To: Rulemaking on AP1000 Reactor Certification
DOCKET ID NRC-2010-0131

From: AP1000 Oversight Group

Re: CONTAINMENT FLAWS IN AP1000 DESIGN

Figure 1

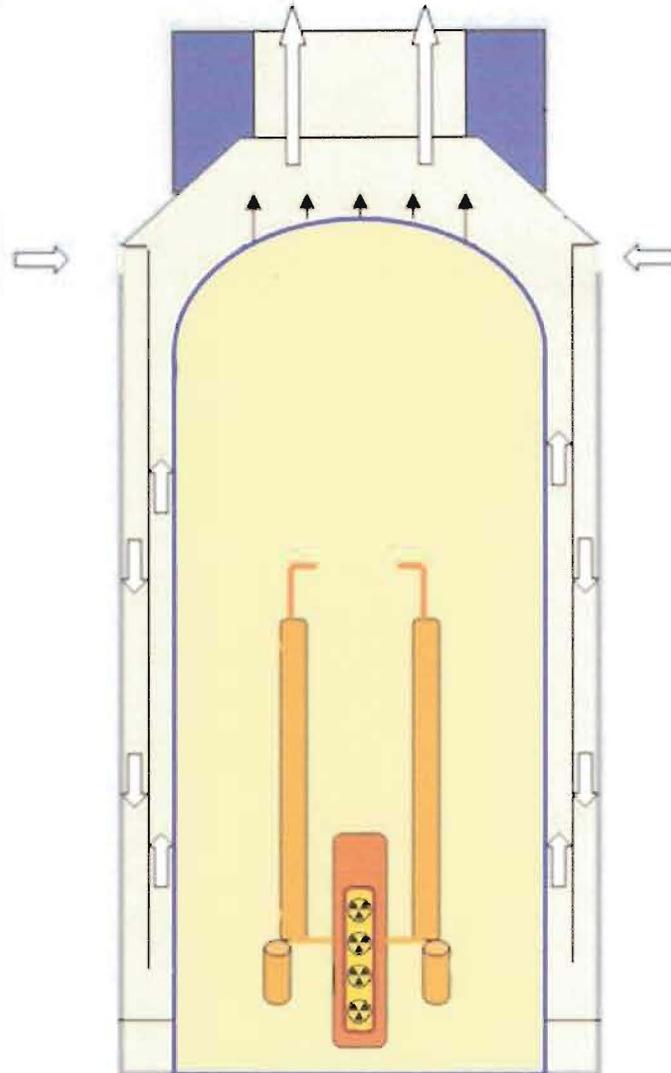
- Figure 1 – AP1000 in normal operation.
- Figure 2 – AP1000 design basis accident begins.
- Figure 3 – AP1000 containment hole opens as containment fills with radioactive gases.
- Figure 4 – AP1000 chimney effect draws radioactivity directly into the environment.

Figure 2

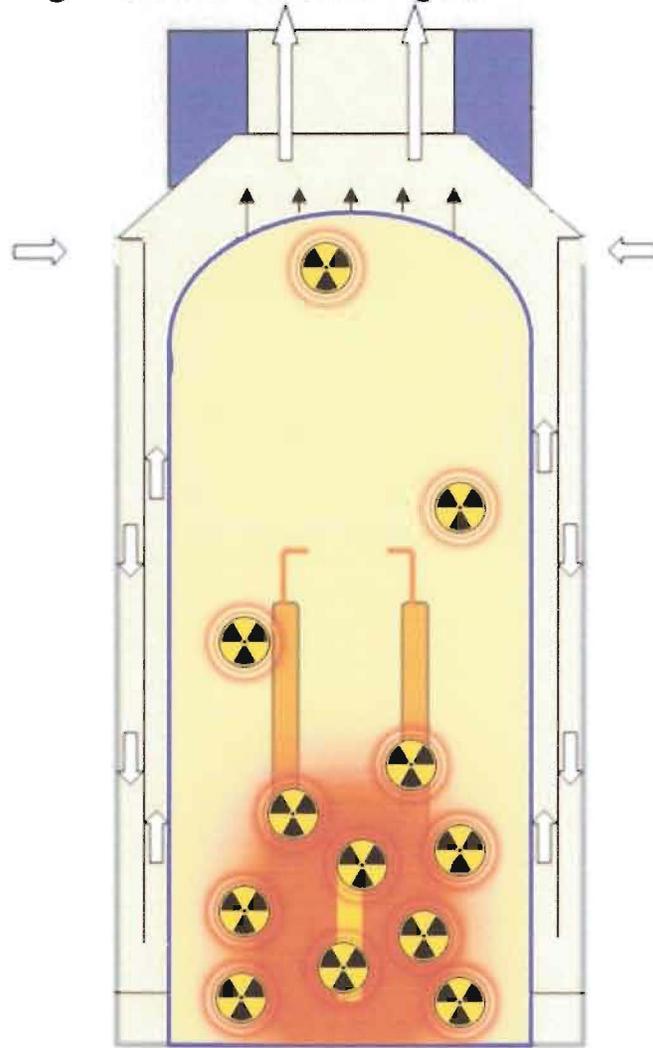
AP1000 Design Basis Accident Begins

Figure 3

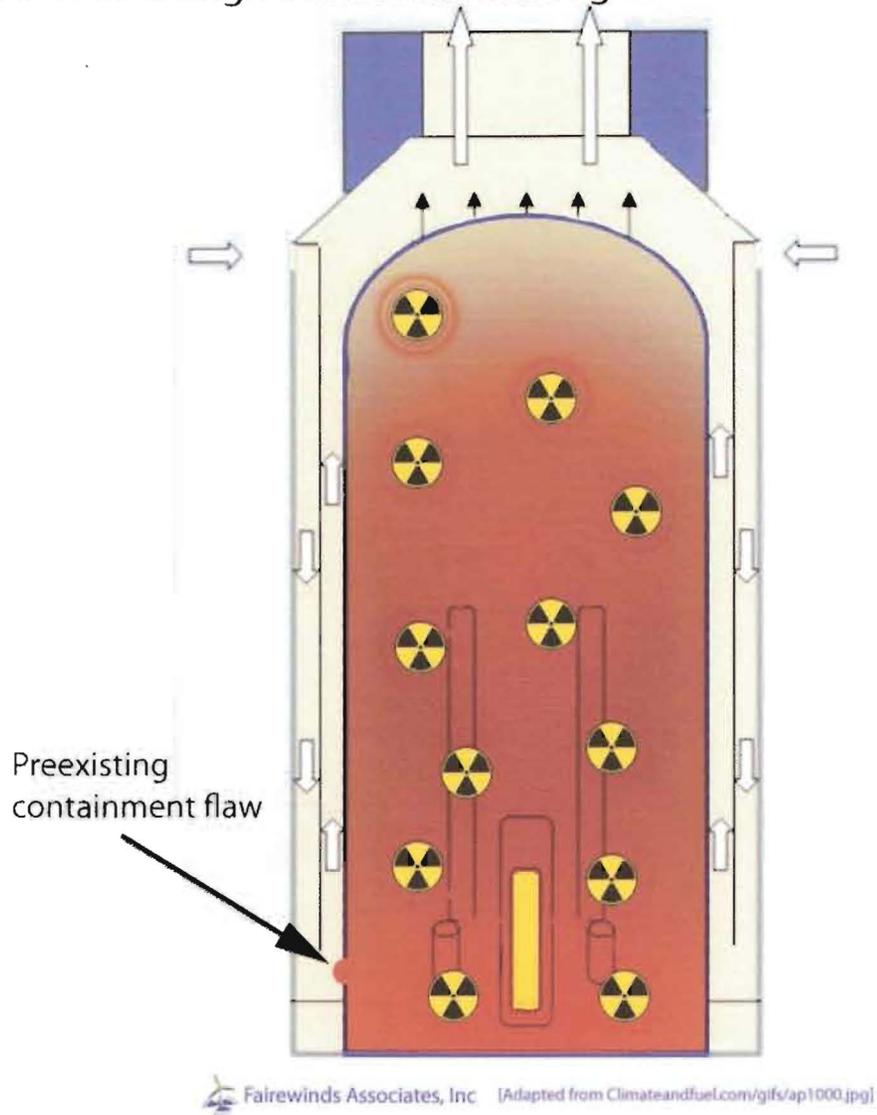
Containment Fills With Radioactive Gases AP1000 Design Basis Accident Begins

Figure 4

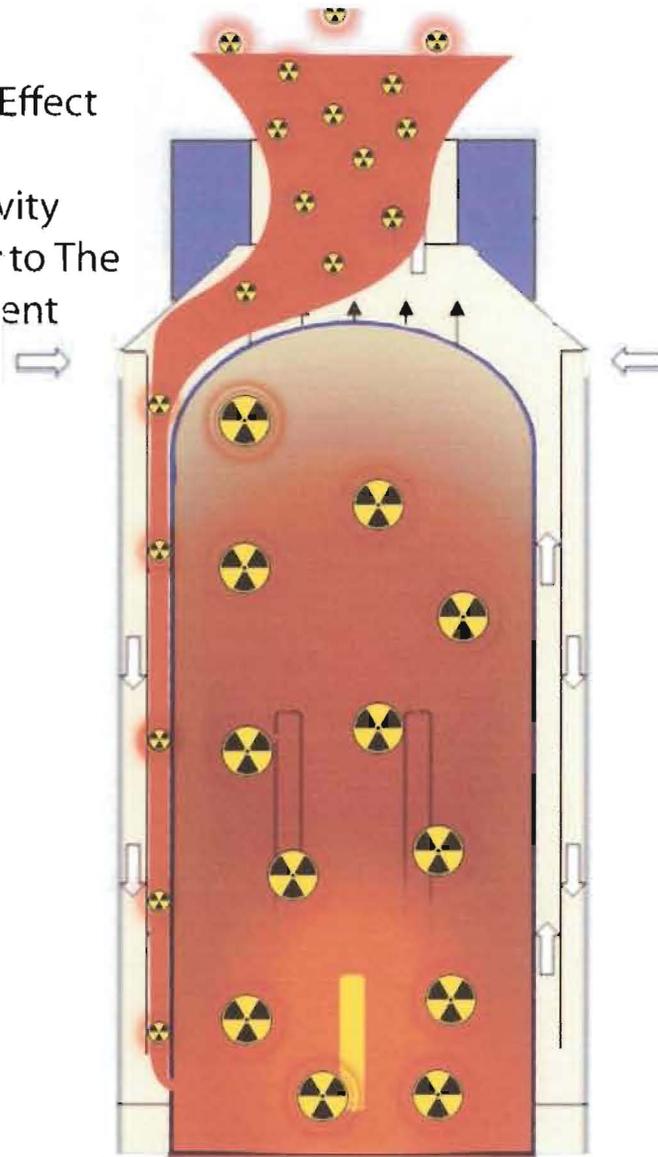
AP1000
Chimney Effect
Draws
Radioactivity
Directly In to The
Environment
